Ballard Pump Station

Project Description

Meeting Summary

Concept Design

Figure 3: Rendering of proposed concept plan

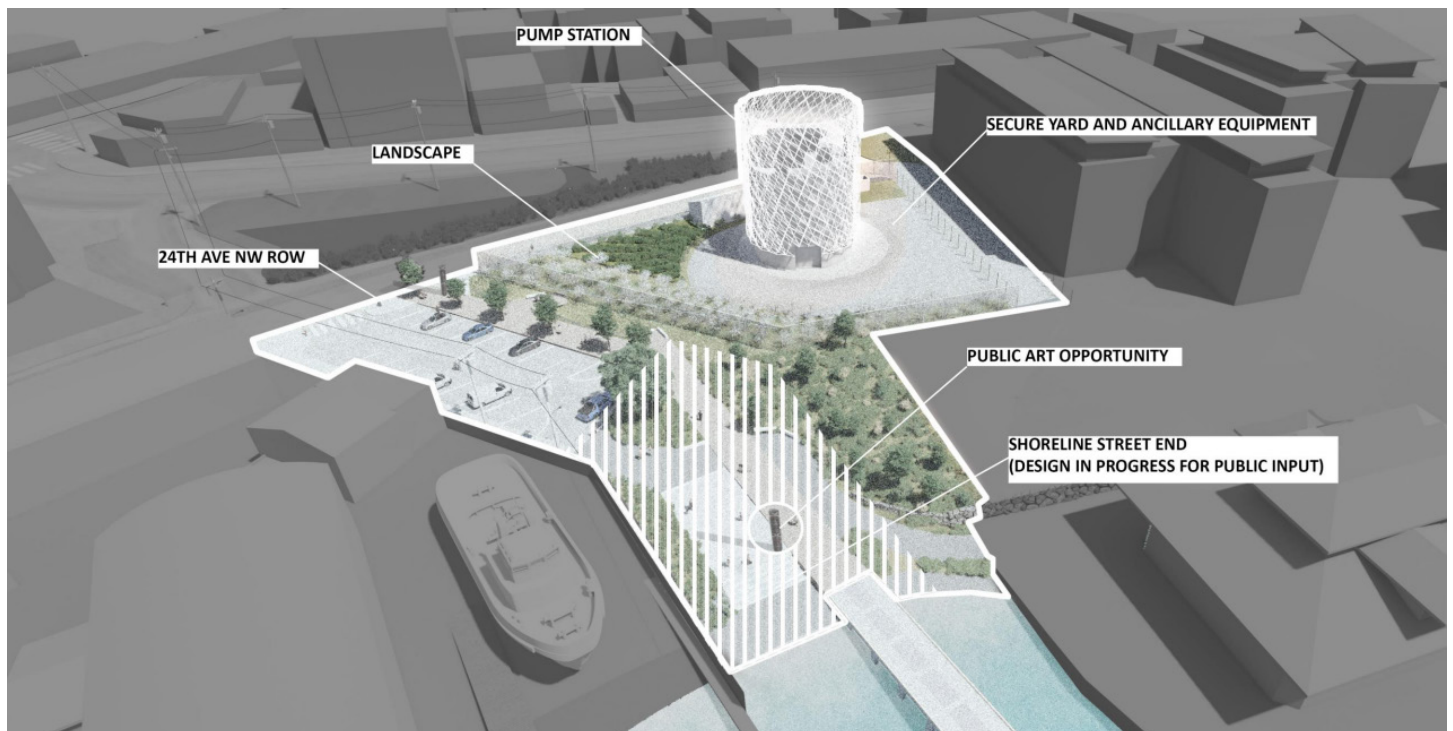
Although The SDC commended the project team for increasing the visibility of a large infrastructure project, commissioners are concerned with the current project proposal due to its lacking a cohesive site design. Commissioners strongly recommended the project team provide a design proposal that includes the pump station and 24th Ave NW street-end, as well as addressing the connection between the street-end and pier. The Commission then commended the project team for providing vegetation in an area that includes limited green space and encouraged the project team to provide more human scaled and interactive elements, specifically with the GSI facilities as well as in other locations across the project site. The SDC then strongly recommended the project team provide a cohesive strategy for the integration of storytelling and interpretive

The Commission then discussed the proposed architectural and planting materials. The SDC recommended the project team consider the long term maintenance when specifying materials for the pump station shroud design. Commissioners requested more information on proposed materials during the next review. The Commission agreed with the project team specifying several tree species and encouraged the team to continue to think through the urban tree farm concept and to consider providing a plan or partnership for maintenance. The SDC questioned the viability of the edible component of the landscape plan. Commissioners were concerned this component would not survive unless there was a plan or partnership in place for long term stewardship of the plants.

The SDC then encouraged the project team to integrate the ancillary facilities within the fence line to the extent possible.

The SDC appreciated the project team specifying a different material for the decorative fence. Commissioners encouraged the project team to consider the cost of the decorative fencing material if it will be used during the interim design period only. The commission then commented that, if the proposed fence line represents the footprint of the future building, then the project team needs to think about the final development when designing the site so not to preclude desired opportunities. The SDC then cautioned the project team from overusing security fencing and encouraged the team to locate the security fence in areas that are absolutely necessary.

The SDC then recommended the project team provide diagrams to better explain circulation to and through the project site. Specifically, commissioners requested more information on circulation over the railroad crossing as well as connections with the adjacent properties.

The SDC strongly recommended that the street-end park development be integrated with the overall plan for the project site. Commissioners also stated that the project team needs to provide a better explanation of how the street-end terminus will be designed as well as how it will integrate with the pier.

1. Better integrate the three components of the project: the pump station, 24th Ave shoreline street end, and future development parcel. Provide clearer solutions for circulation to and through the site for the various phases of development. Address how circulation takes the BNSF railroad tracks into account. Provide a strategy for potential programming on the development parcel in the near and long term.

4. Provide a concept design for the 24th Ave NW shoreline street end that integrates with the pump station site and provides a public connection to the pier
